# Pine Trace Golf Course

## Phase 1 - Driving Range Relocation

**Site Plan Review**  
Reviewed for compliance with City Ordinance, Building and Fire Codes Conditions and mark-ups noted throughout plan set must be addressed prior to final approval

**Subject: Pine Trace Golf Course  
Driving Range Relocation Project  
Site Plan Review #1,  
Plans dated August 6, 2024, as received by the  
City of Rochester Hills  
ASTI File No. A24-1482.83**

SHEET TITLE:  
**TOPOGRAPHICAL SURVEY AND REMOVAL PLAN**

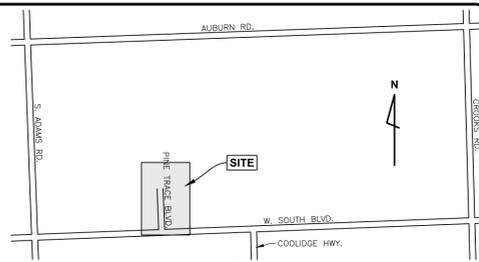
Separate building permits are required for each demolished house. Sheds on the same lots may be combined with the house demolition permits.

Accessory structures are prohibited on lots that do not have a primary residence.

The removal of in-ground swimming pools requires a separate building permit.

Any lighting or netting proposed for driving range will require additional site plan review.

Show driveway removed and curb replaced along S Blvd.  
Permit required from RCOC for work in their ROW.

**GRADING AND LANDSCAPE PLAN**

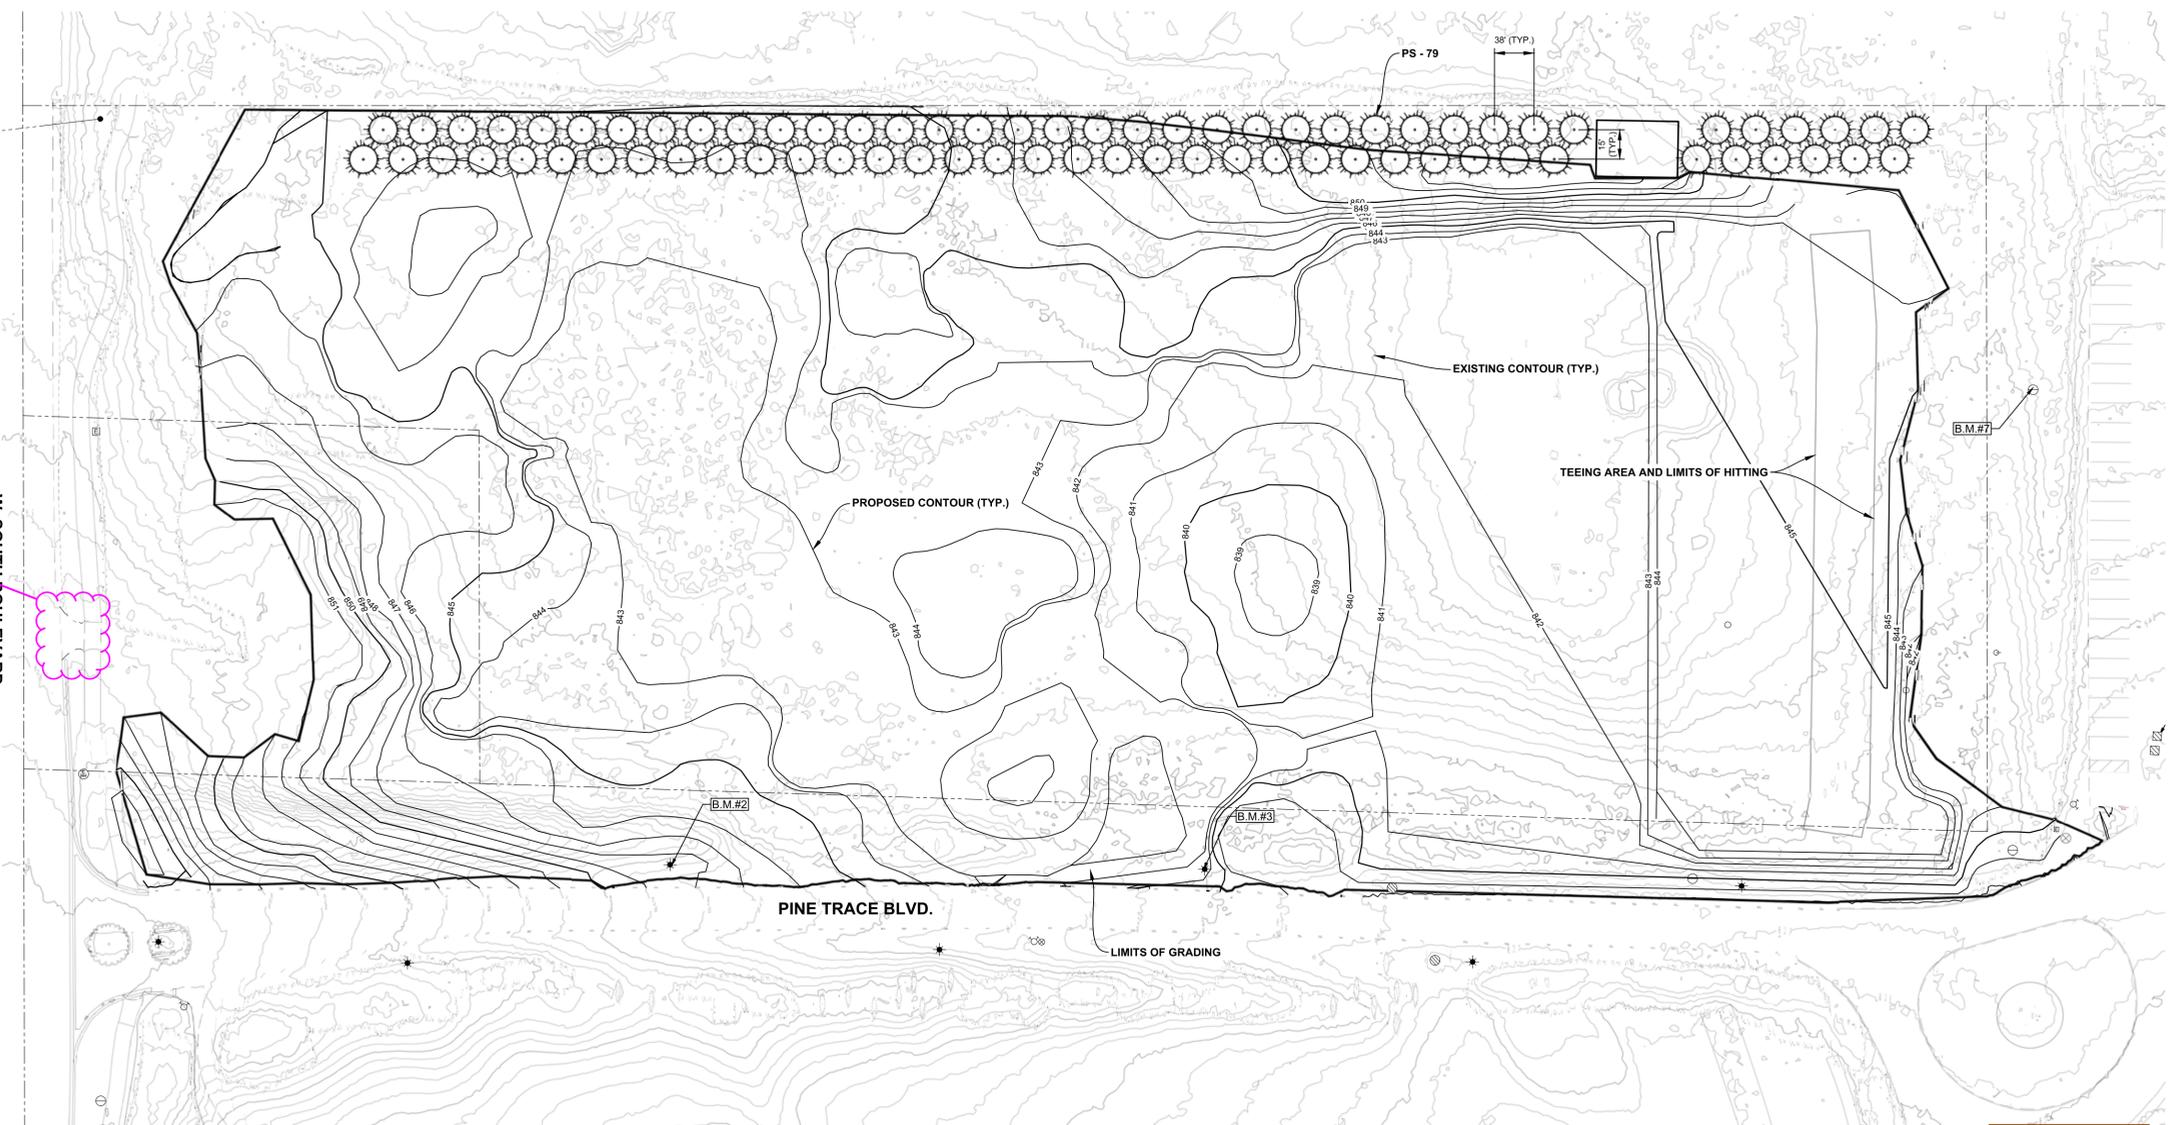
A diversification of evergreens may be appropriate.

Place the storm sewer narrative on either the cover sheet or grading plan and reference it on the cover sheet by the Land Use Summary.

Revise Grading Plan callouts so that the proposed contours to the existing contours are easy to follow throughout

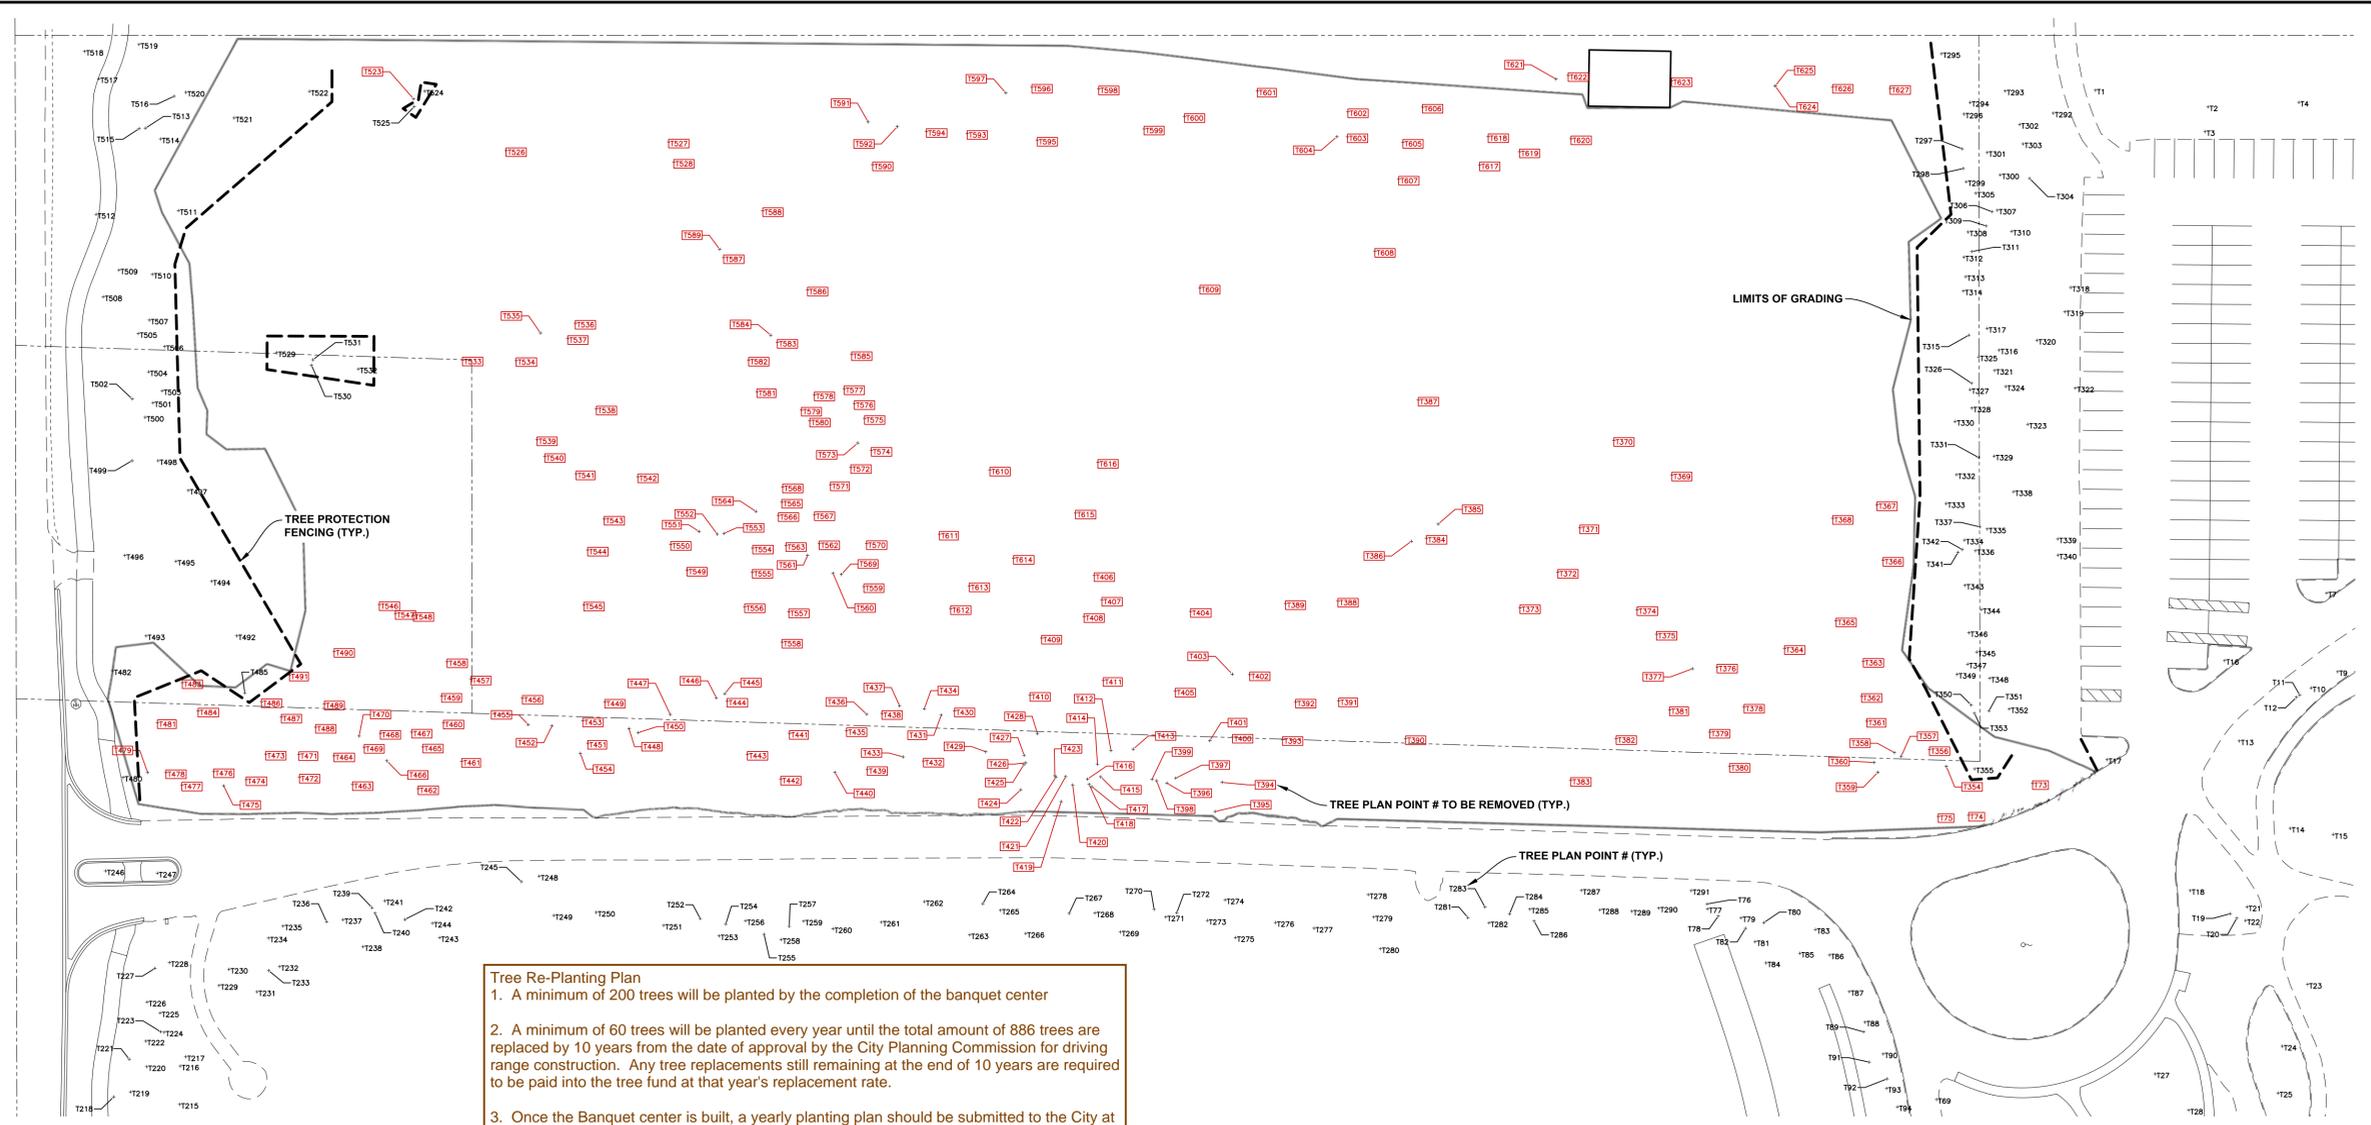
**Tree Re-Planting Plan**

1. A minimum of 200 trees will be planted by the completion of the banquet center
2. A minimum of 60 trees will be planted every year until the total amount of 886 trees are replaced by 10 years from the date of approval by the City Planning Commission for driving range construction. Any tree replacements still remaining at the end of 10 years are required to be paid into the tree fund at that year's replacement rate.

3. Once the Banquet center is built, a yearly planting plan should be submitted to the City at the same time Pine Trace submits its annual report per the lease. Planting plan must be approved by Forestry to count as replacement credit.

4. In the event the banquet center does not get built according to the terms of the current lease, the total amount required for tree replacement must be paid into the City Tree Fund.

5. To count towards replacement credit all trees must meet City requirements of at least 2" dbh. Allowance will be made in some circumstances on City requirements of distance between planting (typically 20 ft).

6. Tree replacement credits will not include any trees required by other City ordinances.
